## Product Change Notice (PCN)

**PCN Number: PCN-0103214R-01**

Product(s) Affected: SMI-AU-1

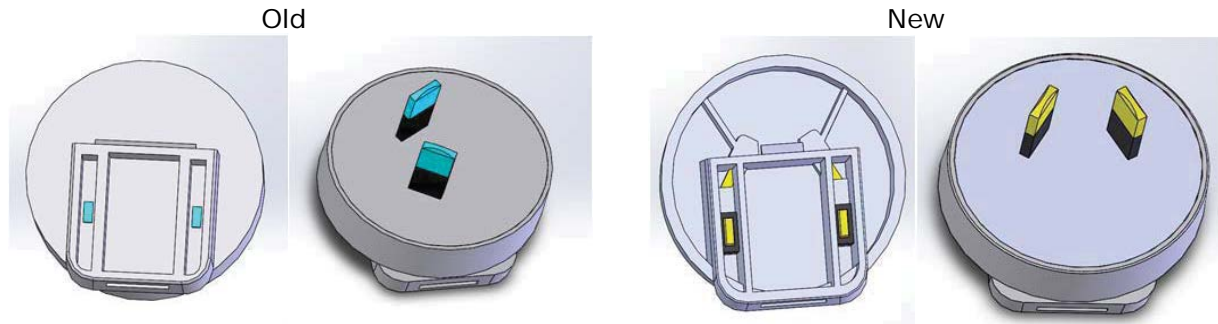
Description of Change: AU multi-blade adapter blade will change from two-piece ultrasonic welded construction to a one-piece molded form.

Primary changes will be distinguished aesthetically on the back (connection side) of the blade, and the orientation of the blades have changed 90 degrees.
